California Investor Owned Utilities Comments: Electronic Displays - Response to Final Staff Report

Response to Final Draft CEC Staff Report,
Revised Analysis for **Computer Monitors and
Signage Displays**

Docket #14-AAER-2

May 23, 2016

Figure 2.2 451 Monitor Models 17 Inch and Greater – Compliant and Non-compliant by 10 Percent or Less

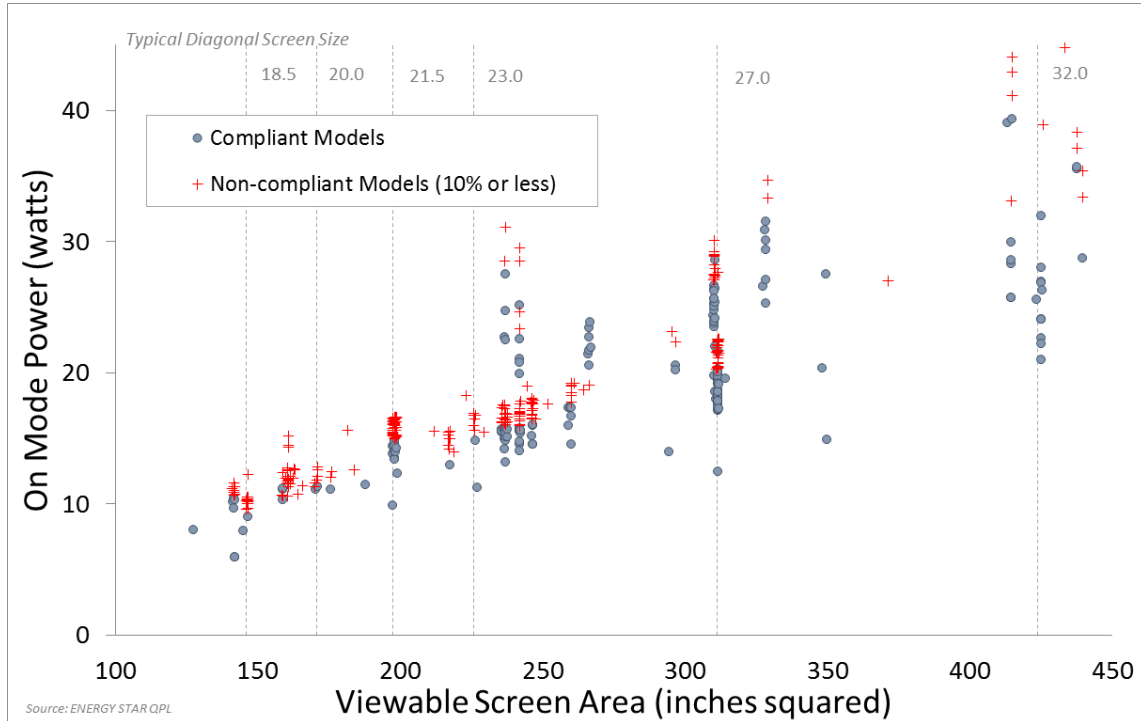
The CASE Team analyzed ENERGY STAR’s Qualified Product List (QPL) to address concerns by industry that monitors would not be able to meet the On Mode power requirements proposed by CEC. Figure 2.2 shows the **451 models** 17 inches and greater, available on the market today, that currently meet (169 models) or are within 10 percent of CEC’s On Mode proposal (an additional 282 models). The 282 non-compliant models within 10 percent exceed the On Mode levels by between 0.06 and 3.84 Watts (W), with the average model exceeding the levels by 1.09 W. That is, the average efficiency improvement that the 282 models would have to make to be *minimally*-compliant with CEC’s On Mode level is a little more than **one watt**. Given the fact that a number

of low cost efficiency improvements are available, we assume that most manufacturers will implement design options for these models resulting in a larger than 1.09 W difference.

Figure 2.3 Comparison of ENERGY STAR Versions 6 and 7 and CEC Proposal Levels

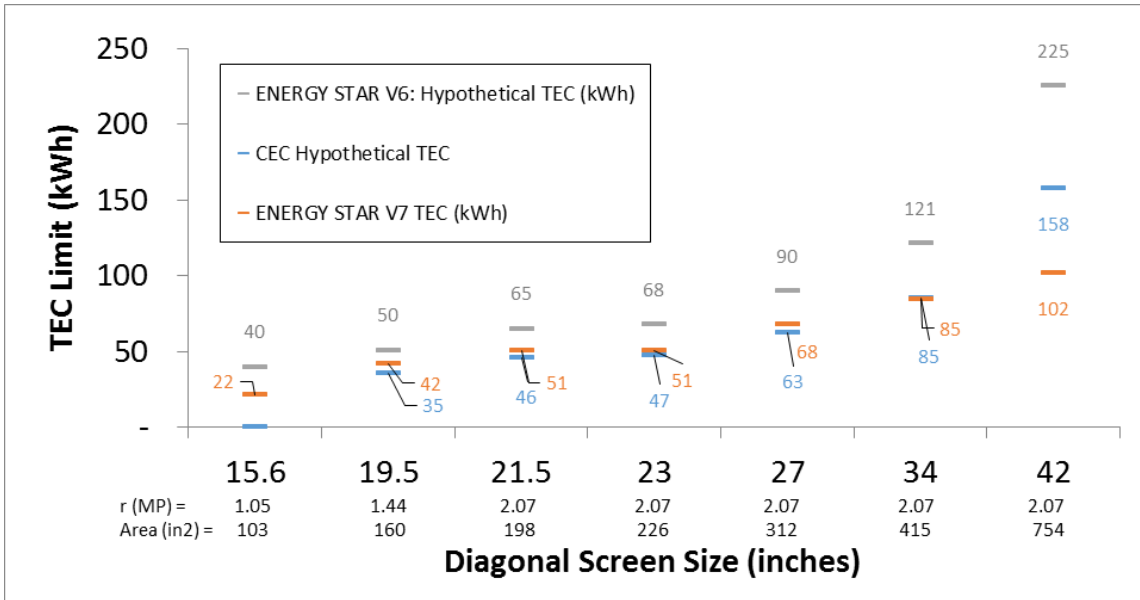
In the Executive Summary of the updated staff report, the CASE Team noted a typographical error in the following statement: “*The proposed regulations are similar to the ENERGY STAR Version 7.0 Standards but are about 30 percent more stringent*” (CEC 2016a). Based on the CASE Team’s analysis, the proposed CEC regulations are about 30 percent more stringent than the Version 6.0 specification, effective since 2013, not Version 7, which will take effect later in 2016. As shown in Figure 2.3 and Table 2.2, using the same duty cycle assumptions as ENERGY STAR, the CEC proposals for On and Sleep Modes (calculated into a hypothetical Typical Energy Consumption [TEC] value to be able to compare to Version 7) closely match the Version 7 levels, with one major exception: 42 inch and larger. In this size category, the proposed CEC level is significantly more lenient (greater than 50 percent) than the ENERGY STAR level.

Figure 2.4: IOU Proposed Maximum On Mode Power Limits, with Additional Size Bin for 29 Inches and Larger Displays

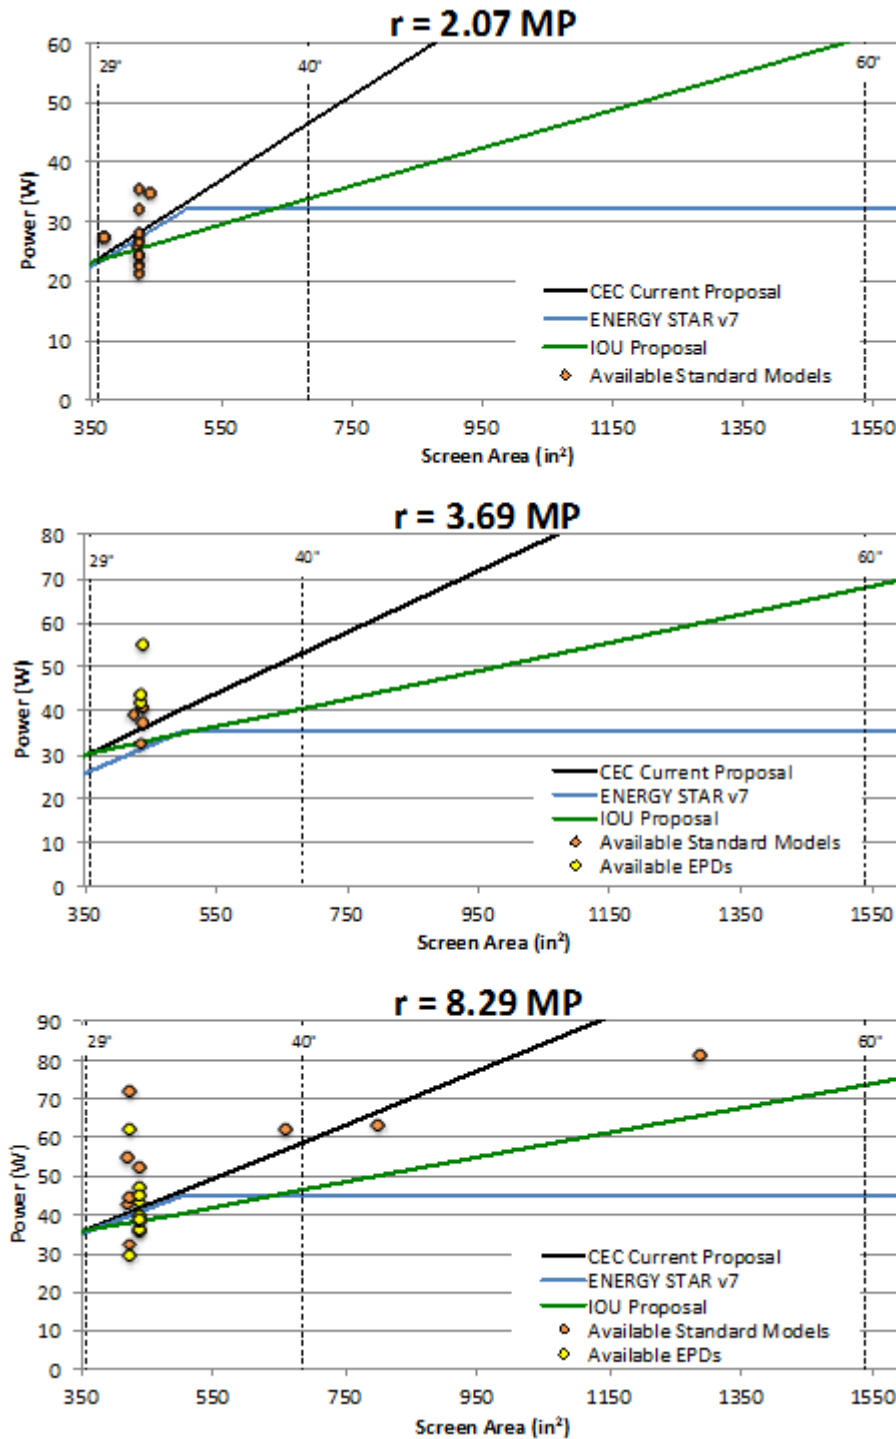
To provide appropriate maximum power levels in the 25 to 29 inch size range, the largest size bin in the updated staff report has a steep slope that results in very large maximum power levels for the largest displays (those more than 29 inches). To prevent increasing energy use by large displays, the IOUs propose an additional bin that includes displays 29 inches and larger as shown in Table 2.3. The CASE Team proposes a maximum power equation that has a shallower slope and therefore prevents very large power allowances for the largest screen sizes shown in Figure 2.4. Also in Table 2., the CASE Team proposes using screen area instead of the diagonal screen size for the size bins. This update simplifies the On Mode power calculation, aligns with the updated ENERGY STAR approach, and avoids inconsistencies that arise because of widescreen displays and a range of aspect ratios that are available in monitors today. More details on this recommendation, including an example, are provided in Section 2.6.

Figure 2.5 Comparison of On Mode Versus Resolution for Computer Monitors

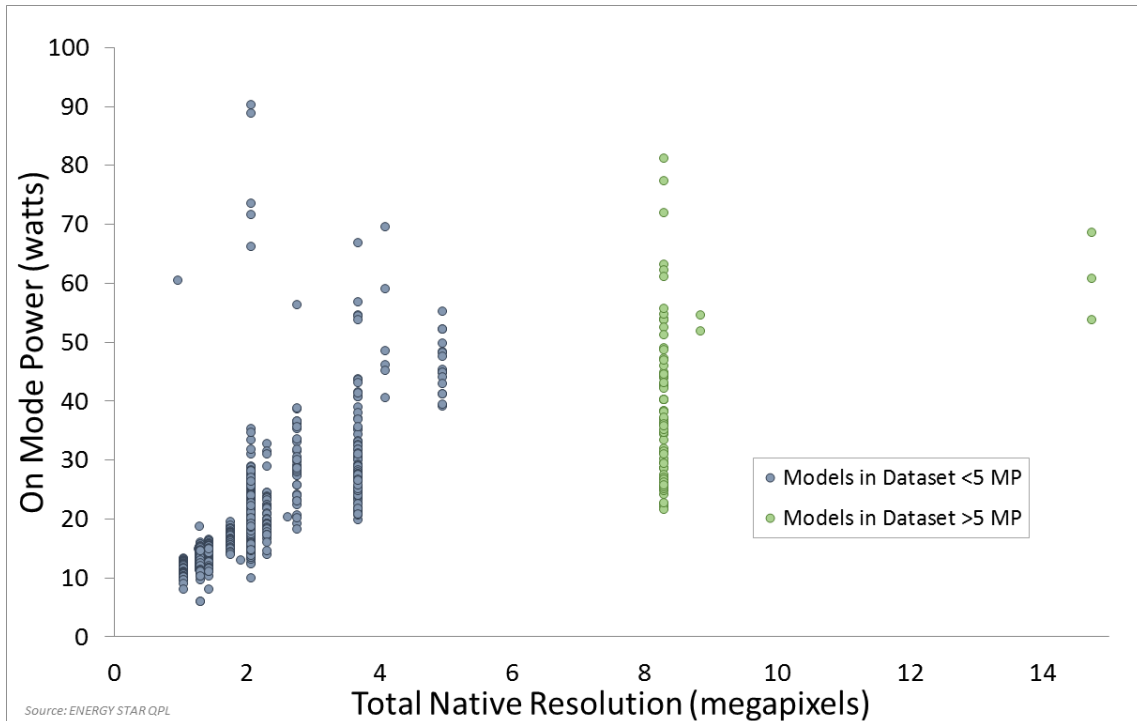
The CASE Team strongly supports CEC’s proposal of a constant resolution allowance greater than 5 megapixels (MP). For LCDs, higher resolution does increase power draw to some extent. Higher

resolution means more pixels, increasing the area of the electronics that control pixel operation, and reducing the transmissivity of the panel. To maintain screen luminance, this requires increased output from the backlight, which correlates to increased display power. This was the rationale for including a power adder based on resolution into the CASE Team’s originally proposed On Mode requirements (CA IOUs 2013). While we continue to support a resolution allowance that scales with size up to a certain point, our analysis of the model specific data shows that there is an incremental power demand as resolutions increase up to 5 MP. Past that resolution, the incremental power demand decreases as resolution gets higher as shown in Figure 2.5.

Figure 2.6 Computer Monitors 2.07 MP and Greater That Meet On Mode Requirements

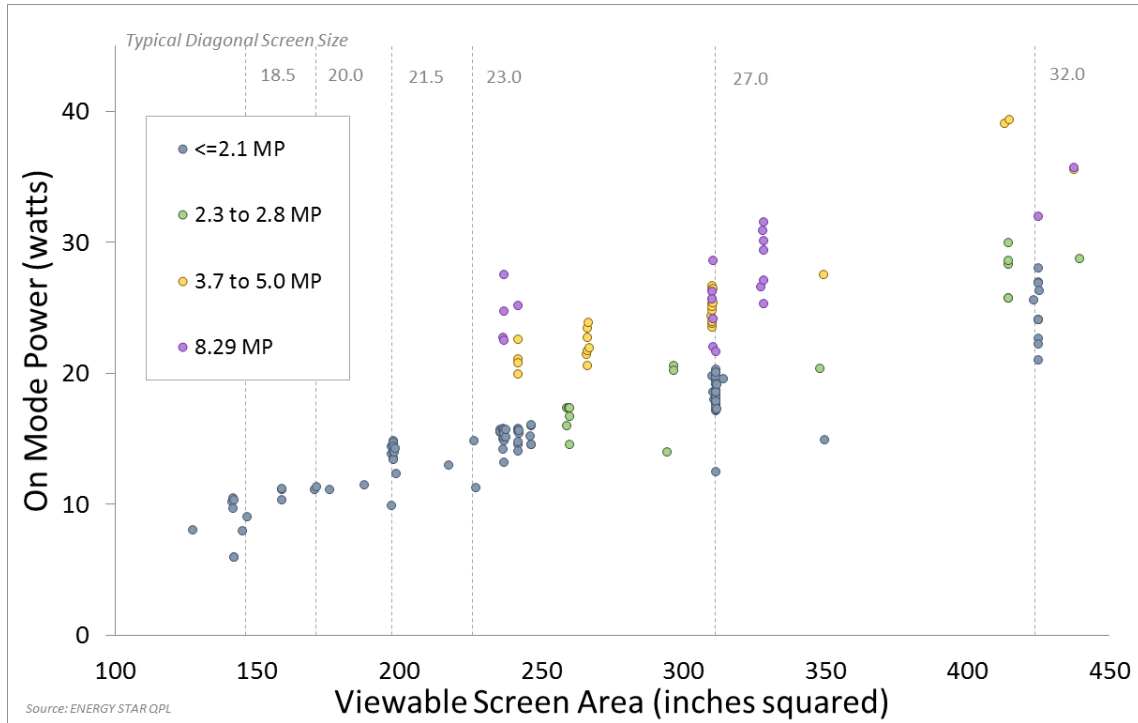
The constant resolution allowance past 5 MP also addresses the previous concern the CASE Team commented on that using that previous CEC proposal, a high-resolution model could consume almost five times as much power as similar size efficient model while still meeting the On Mode limits (CA IOUs 2015a). Figure 2.5 shows all the models at multiple resolutions available today from multiple manufacturers that would meet the updated CEC proposal. In addition to the standard 2.07 MP models, some of the newest, highly featured 4K models (noted as 8.29 MP) are able to meet the updated CEC On Mode proposal. These models, some of the newest on the market today, would not have to make any modifications to meet the proposed requirements.

Figure 3.1 Touch Screen Monitors: Sleep and Off Modes

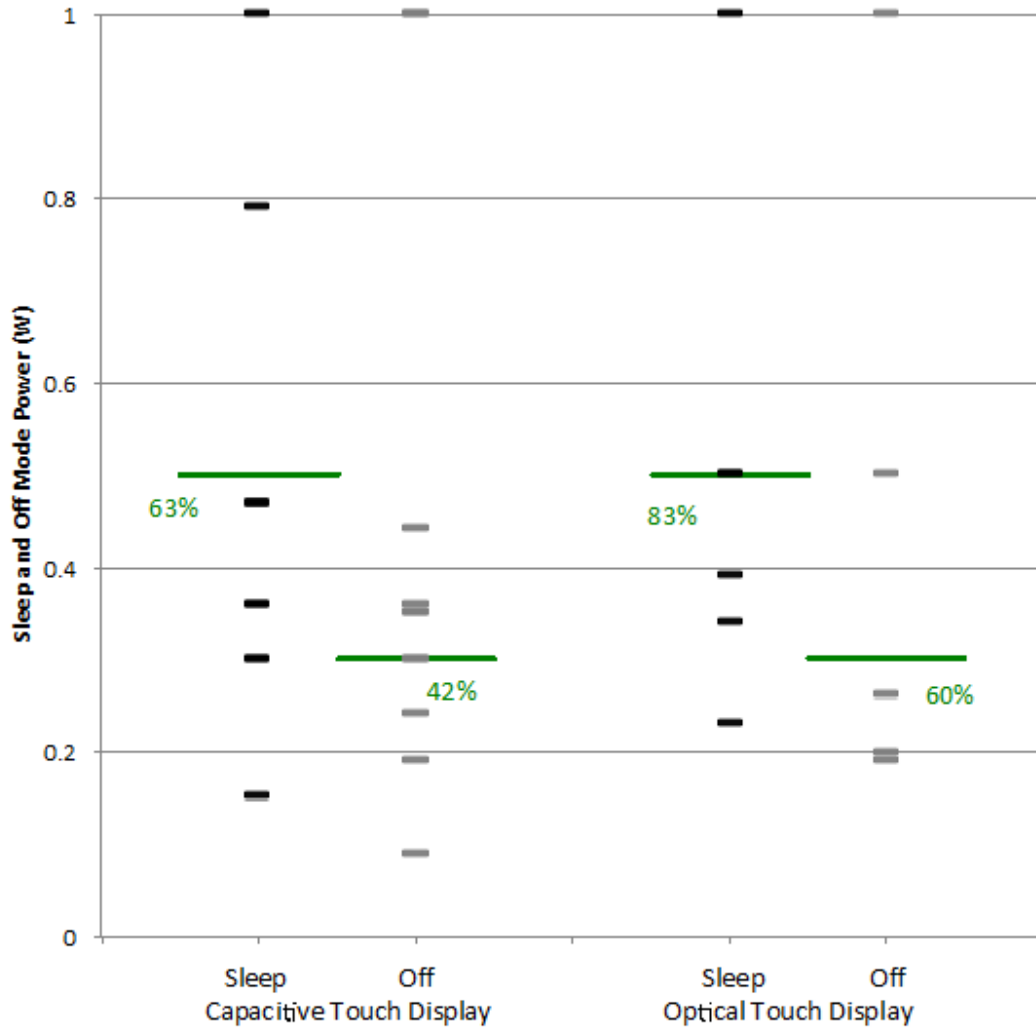
At least four touch screen technologies are present in displays on the market today: resistive, capacitive, optical/infrared, and surface acoustic wave (SAW). Resistive and SAW appear to be rarely used in computer monitors; the IOUs found only one model for each of these technologies through an internet search and were not able to determine Sleep and Off Mode power information for these models. Capacitive touch screens are the most prevalent touch technology in computer monitors. They are also a popular choice for mobile products and use can use minimal power when waiting to detect touch input⁵. Of the 13 computer monitors identified with power information, 63 percent would comply with the CEC’s updated Sleep Mode power limit (Figure 3.1). Optical touch screens use infrared LEDs to create a grid of light across the screen and sensors that detect the interruption of that light and the coordinates of the touch. Thus to wake the display from Sleep Mode with a touch on the screen, lights and sensors must be active. Of the six optical touch screen models we identified, all but one would comply with the CEC’s Sleep Mode proposal (Figure 3.1). In Figure 3.1, Sleep (black dashes) and Off (grey dashes) Modes are displayed for capacitive (left) and optical (right) touch screen displays. The green lines show CEC’s proposed limits of 0.5 W and

0.3 W for Sleep and Off Modes, respectively. The percentage of models that would comply with each modal power level is shown in green type. We show power data up to 1.0 W for clarity, however, not shown are two capacitive touch screen models with Sleep Mode power of 2.0 to 2.5W. The calculated compliance rate of 63 percent includes these two models.

Based on the available information, the CASE Team finds that touch screen monitors can comply with the CEC Sleep and Off Mode levels of 0.5 W and 0.3 W and support this change.

Figure 4.1 On Mode power of Type II EPDs by Area and Resolution: 2.76 MP (red diamonds, n=1), 3.69 MP (blue diamonds, n=11), and 8.29 MP (green diamonds, n=4). Dashes show the IOUs’ proposed maximum On Mode power for the area and resolution of the models shown.

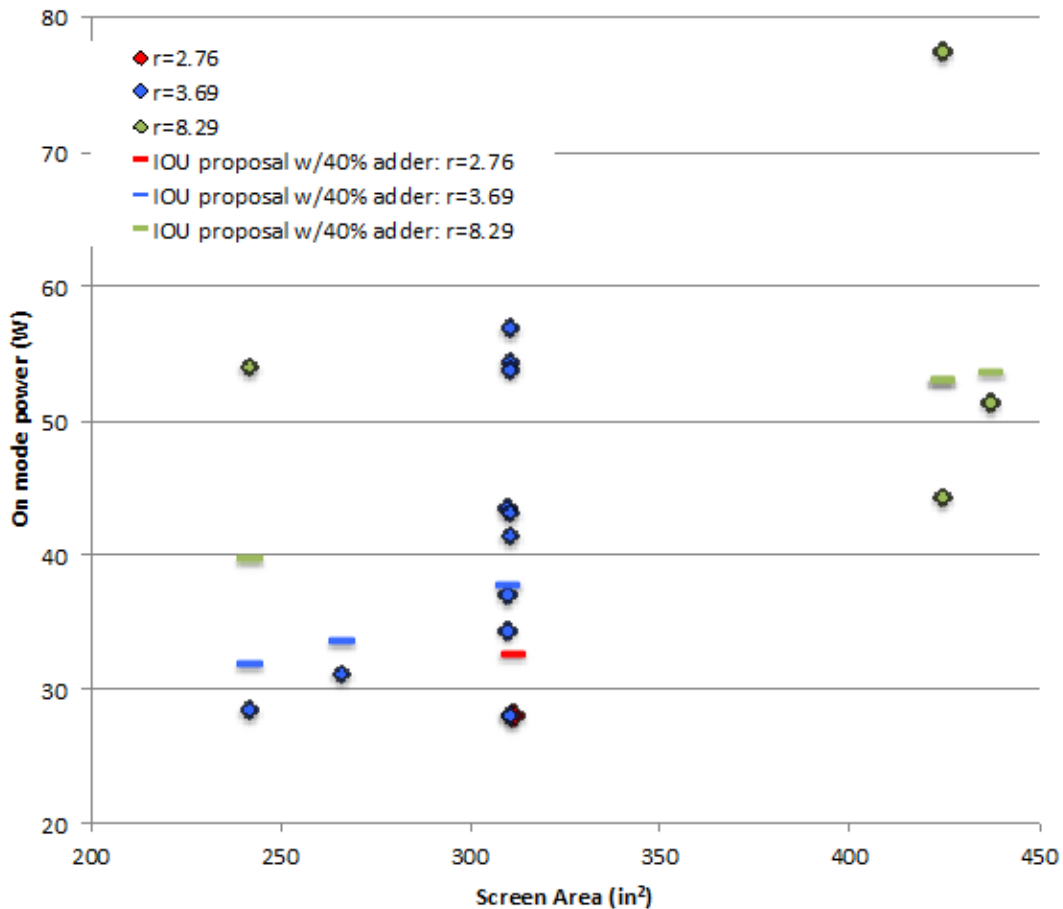
The CASE Team has previously outlined a path to compliance without an adder for Type II EPDs that use colored LEDs to produce their broad color gamut (CA IOUs 2015b). In this scenario, high efficacy LEDs, quantum dot film, and a LCD panel with typical color filters replace the low efficiency colored LEDs and LCD panel with more saturated color filters. 3M estimates that displays produced with these updates can be up to 50 percent more efficient than current models with colored LEDs.⁶ Although concrete cost information is not available, the CASE Team estimates that the improvements are cost-effective. The increased cost for quantum dot film could be offset,

Because a technically feasible path to compliance exists, CEC should phase out the proposed power adders for Type II EPDs 2 years after Title 20 Standards take effect. This approach to sunset the power allowance also accounts for the fact that LED technology will continue to make significant improvements in the near future with respect to quality and efficiency.
